NUMBER: 18-078-16

Engine Oil Viscosity Upgrade And Flash Enhancements

2016 (WK) Jeep Grand Cherokee 2016 (DS) Ram 1500 Pickup

Fig. 1 Cap Before Sticker Applied

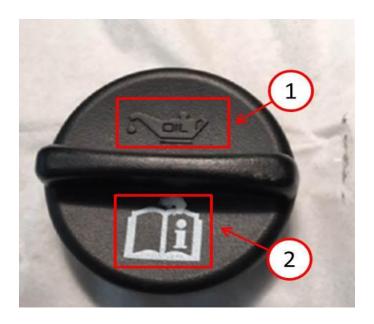
- 5. Run engine for 10 minutes before oil change to warm up the engine oil.
- 6. Remove oil fill cap.
- 7. Clean top of oil fill cap with Isopropyl alcohol or equivalent and apply engine oil viscosity rating sticker as shown in (Fig. 1).

- 1 Do Not Cover This Embossed International Oil Symbol
- 2 Cover This Old Oil Info Symbol With The New "5W40" Label
- 8. Remove the oil drain plug and allow oil to drain for at least 5 minutes or until it stops dripping.

Fig. 2 Damaged Rubber Seal

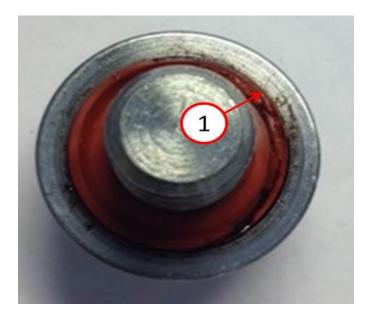
9. Inspect the oil drain plug and gasket for damages (Fig. 2). Replace if necessary.

1 - Oil Drain Plug Gasket Seal Crushed
